Docket Nos. 50-269  
50-270  
and 50-287

The Commission has issued the enclosed Amendment Nos. 57, 57 and 59 for License Nos. DPR-38, DPR-47 and DPR-55 for the Oconee Nuclear Station Unit Nos. 1, 2 and 3. These amendments are in response to your application dated March 1, 1977 as supplemented December 15, 1977.

The amendments revise the Oconee Technical Specifications to incorporate requirements for fire protection.

AMENDMENT TO FACILITY OPERATING LICENSE

OCONEE NUCLEAR STATION  
STATION ORGANIZATION CHART  
FIGURE 6.1-1

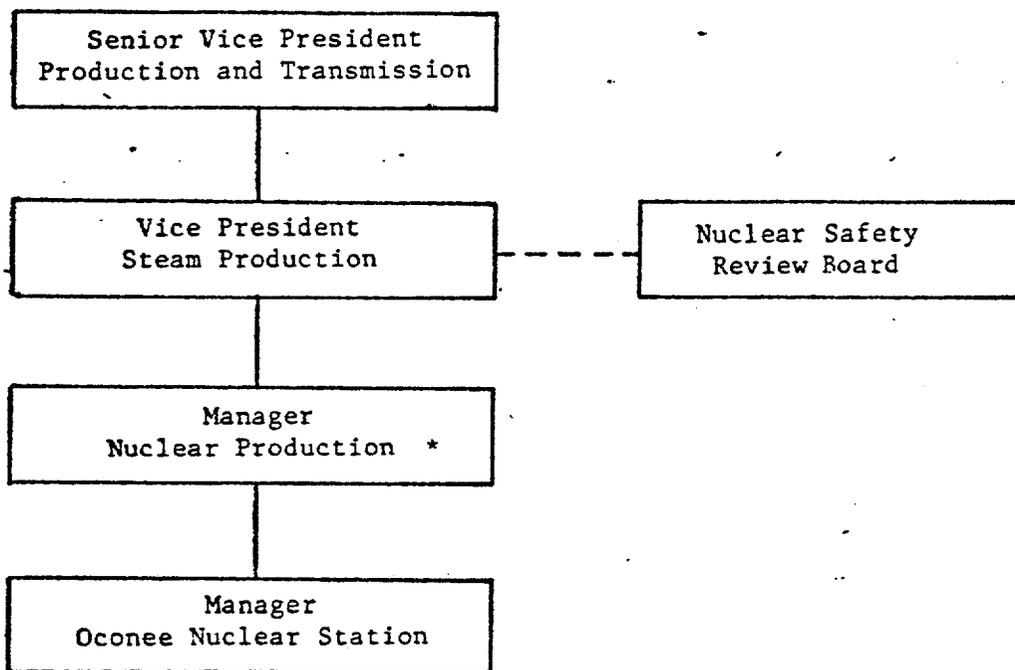
\*Responsible for Fire Protection Program
